UNITED STATES PATENT AND TRADEMARK OFFICE

APPLICATION NO.	FILING DATE	FIRST NAMED INVENTOR	ATTORNEY DOCKET NO.	CONFIRMATION NO.
10/666,595	09/18/2003	Elliott Malcolm Philofsky	ACR-0301	8539

Office Action Summary	Application No. 10/666,595	Applicant(s) PHILOFSKY, ELLIOTT MALCOLM	
	Examiner Eric W Thomas	Art Unit 2831

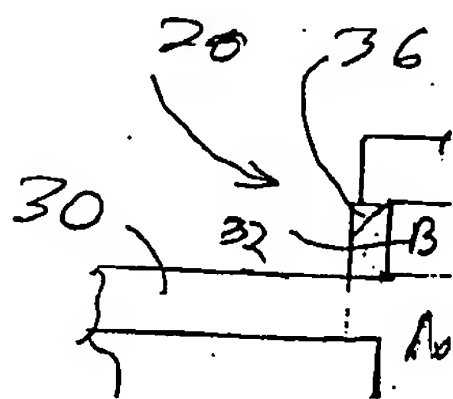
6. The drawings are objected to because one of the reference numbers is not clear (see below)

Is this element 28 or 20?

7. A proposed drawing correction or corrected drawings are required in reply to the Office action to avoid abandonment of the application. The objection to the drawings will not be held in abeyance.

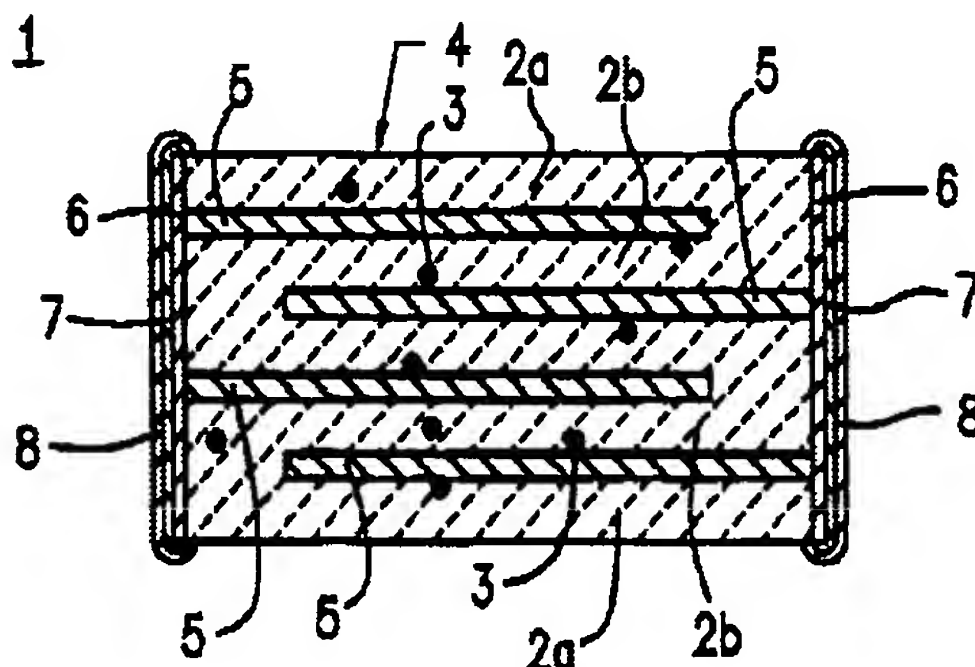
Hata et al. disclose in fig. 1, a capacitor comprising a first nickel (col. 5 lines 1-4) electrode (5); a BCTZ dielectric (see example) dielectric covering a side of the first nickel electrode; and a second nickel (col. 5 lines 1-4) electrode (5) sandwiching the BCTZ.

FIGURE 1D

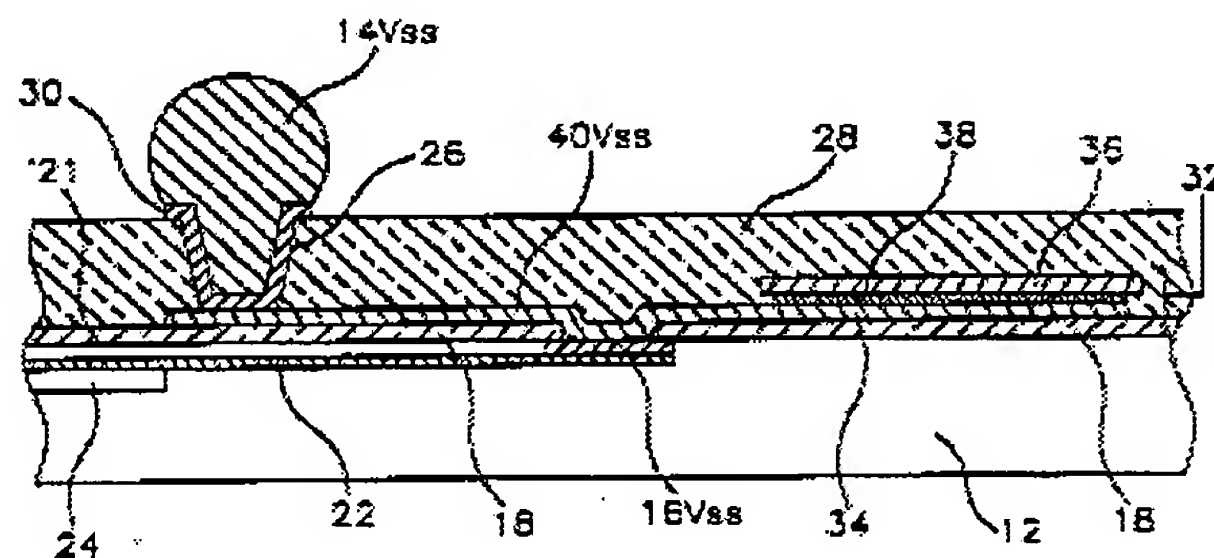
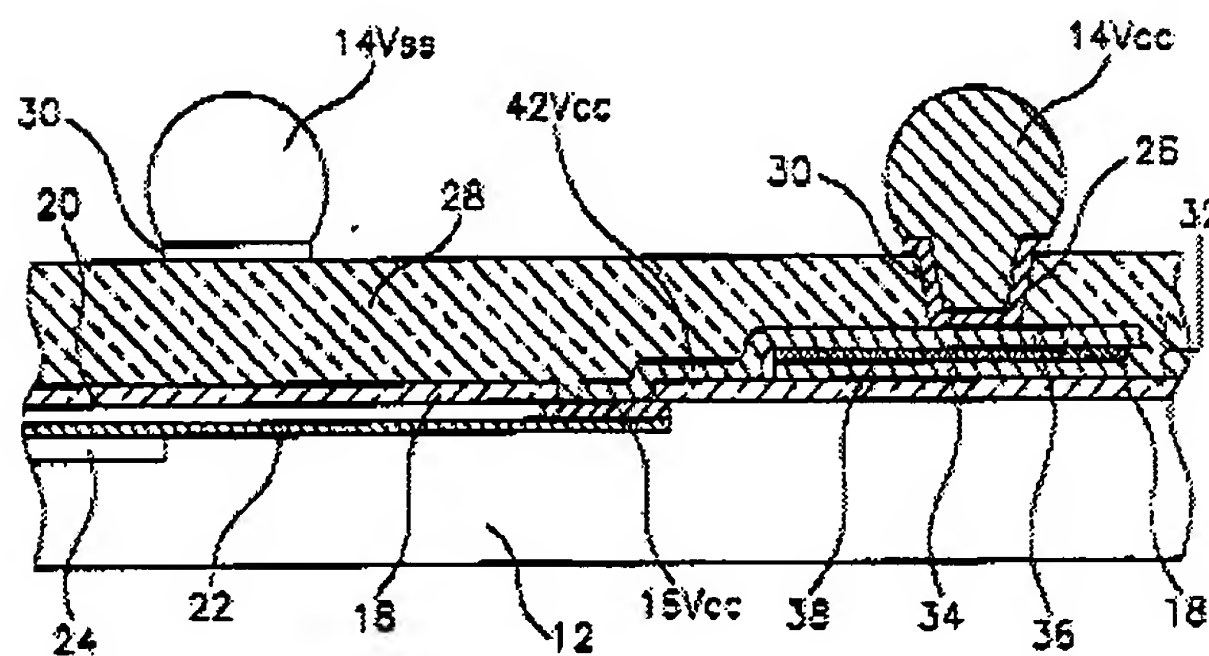
Akram et al. disclose in fig. 1D, 1E, a capacitor for an integrated circuit a first nickel electrode (34) coupled to an electrical lead of the integrated circuit; a dielectric

(38) applied to the first nickel electrode; and a second nickel electrode (36) applied to the dielectric and attached to a second electrical lead of the integrated circuit.

Regarding claim 9, Akram et al. disclose a portion of the second electrode on a passivation layer (18) of the integrated circuit.

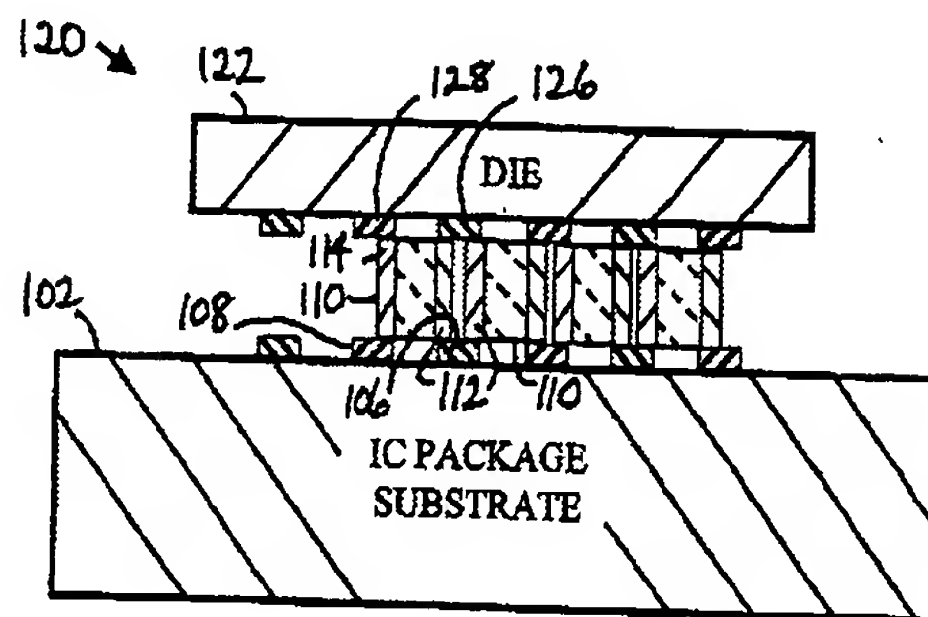
Patel et al. disclose in fig. 4, a capacitor connected to an integrated circuit.

Regarding claim 4, Patel et al. disclose the capacitor (first electrode) is adjacent to a lead on an integrated circuit (pad – 106, 108). Patel et al. disclose the claimed invention except for the lead on the integrated circuit is formed from an aluminum material. Aluminum is a well-known material used as lead (pads) in the IC/capacitor art. It would have been obvious to a person of ordinary skill in the art at the time the invention was made to form the leads of Patel et al. with an aluminum material, since it has been held to be within the general skill of a worker in the art to select a known material on the basis of its suitability for the intended use as a matter of obvious design choice. In re Leshin, 125 USPQ 416.

Regarding claim 6, Patel et al. disclose the second nickel lead is connected to solder bumps (126, 128).

Regarding claim 7, Patel et al. disclose in fig. 4, a capacitor for an integrated circuit wherein a first electrode is connected to an electrical lead of the integrated circuit (pad – 108), a second electrode is connected to a second electrical lead of the integrated circuit (pad – 106).

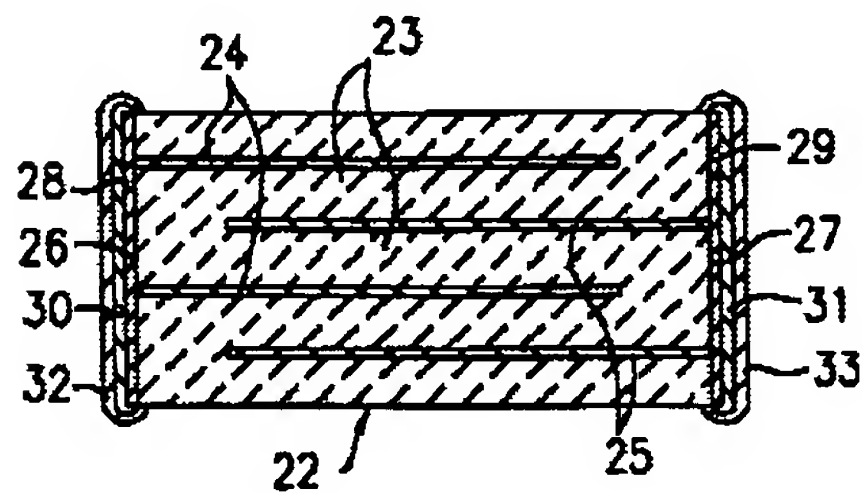
Konaka et al. teach in fig. 1, a capacitor comprising a first nickel (col. 7 lines 13-18) electrode (25); a BCTZ (see abstract) dielectric covering a side of the first nickel electrode; and a second nickel (col. 7 lines 13-18) electrode (24) sandwiching the BCTZ.

Regarding claim 5, Konaka et al. teach that the capacitor has nickel (col. 7 lines 53-56) leads (30, 31). Patel et al. disclose the capacitor is connected to a second lead on the integrated circuit. Patel et al. do not disclose the second lead is formed from an aluminum material. Aluminum is a well-known material used as lead (pads) in the IC/capacitor art. It would have been obvious to a person of ordinary skill in the art at the time the invention was made to form the leads of Patel et al. with an aluminum material, since it has been held to be within the general skill of a worker in the art to select a known material on the basis of its suitability for the intended use as a matter of obvious design choice. In re Leshin, 125 USPQ 416.
